Status: National Body Position, Rep. of KOREA

Subject: Korea's additional information and comments

RE: Korea's vote for ISO/IEC 10646 FPDAM5

1. More information RE: T2

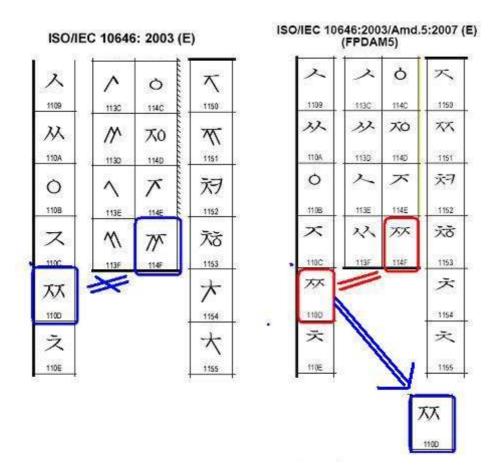
In our Technical comment T2, "U115F" is simply a typo and should read "U114F" in two places (as indicated below).

T2.1 Replace the glyph for U110D with a correct one.

- The glyph for U110D is the same as that for U115F.
- The glyph for U115F is fine.
- However, the glyph for U110D is incorrect and therefore should be changed.
- We will provide the corrected font. <<<end of Korea's vote>>>

T5. p. 34, left column

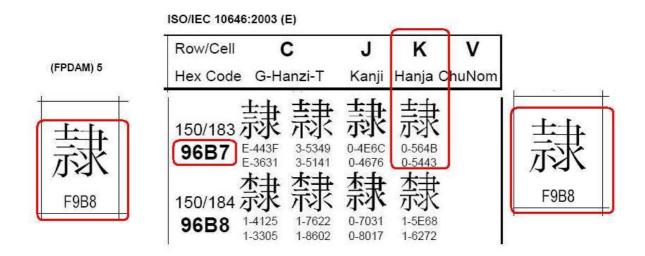
- For UF9B8, the correct mapping seems U96B7, NOT U96B8.
- We suggest that
 - 1) delete 96B8 entry and
 - 2) keep 96B7 entry only.
- <<< end off Korea's vote>>>
- 2.2 Additional information supporting our request.

- 1) By checking the glyphs in FPDAM5 and 10646:2003, we can see that UF9B8 should be mapped to U96B7, not to U96B8.
- 2) Furthermore, duplicate Hanja characters are included in KS X 1001 (KO), but not in KS X 1002 (K1).
- Therefore, any compatibility Hanja characters (whose source is KO, including UF9B8) must be mapped to a KO Hanja (in this case, U96B7), but not to K1 Hanja (in this case, U96B8).
- 3) In CJKU_SR.txt, we know that U96B7 is a KO Hanja and U96B8 is a K1 Hanja.

1) Change the following information:

F9B8 隷 CJK COMPATIBILITY IDEOGRAPH-F9B8 ≡ 96B7 隷 cjk unified ideograph-96B7

2) Change the following line in CJKC_SR.txt - 096B8 ---> 096B7

(current) 0F9B8;096B8;;;;K0-6766;; ---> (new) 0F9B8;096B7;;;;K0-6766;;

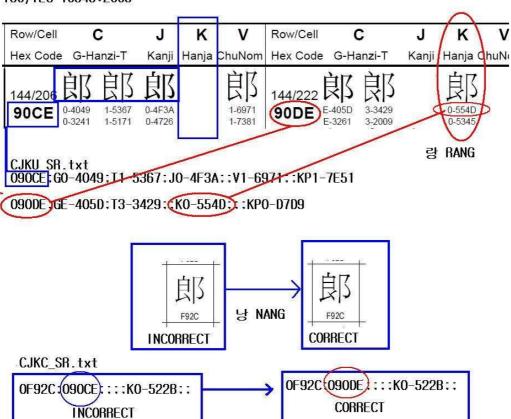
- 3. T8: An additional comment RE: Korea's vote for ISO/IEC 10646:FPDAM5
- 3.1 Mapping info RE: duplicate Hanja in KS X 1001 (and comp. Hanja in UCS)
 - source: Korea JTC1/SC2 documents K1645 and K1646 (= SC2/WG2 N3420 and 3421, respectively).
 - 낭 NANG KO 0x522B, (50-11: row-col), 0xD2AB, U+F92C 랑 RANG KO 0x554D, (53-45: row-col), 0xD5CD, U+90DE
- 3.2 Exact glyphs of two Hanja characters in KS C 5601 are shown below:
 - -50-11 Ox522B (=D2AB) and 53-45 Ox554D (=D5CD)
 - As we can see, their glyphs are exactly the same.
 - source: KS C 5601-1987 (<-- International Register 149)
 (http://www.itscj.ipsj.or.jp/ISO-IR/149.pdf)</pre>
 - The number of strokes for these two characters is 8 + 3 = 11, not 7 + 3 = 10.

- since the glyph of U+F92C (0x522B) is different from the glyph of 랑 (0x554D, 53-45, 11 strokes), U+F92C (0x522B) SHOULD NOT HAVE BEEN encoded as compatibility Hanja.
- Instead, we could simply fill the "currently empty" K column for U+90CE with "K0-522B/K0-5051".
- Therefore, we can conclude that the glyphs of "낭 (0x522B, 50-11)" and "랑 (0x554D, 53-45)" in KS C 5601 are exactly the same and the number of their strokes is 11.

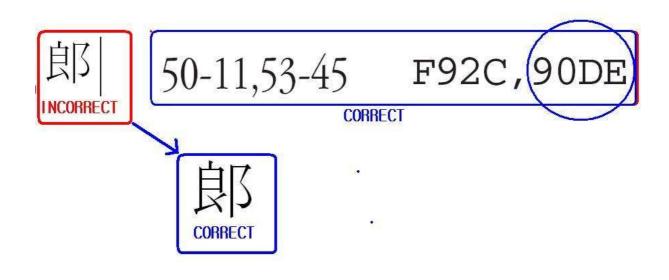
- 1) Change the glyph for U+F92C in FPDAM5 (p. 29) as shown in the picture below.
- We need to add one more stroke (i.e., The number of strokes need to be changed from 10 to 11).

2) Change one line in CJKC_SR txt file of FPDAM5 as shown above:

OF92C; O90CE;;;;K0-522B;; ----> OF92C; O90DE;;;;K0-522B;;

- 3) Change two lines in FPDAM5 (p. 31) as shown below:
 - 3.1) Change 90CE to 90DE
 - 3.2) Change glyphs of two Hanja characters from 10 strokes to 11 strokes.
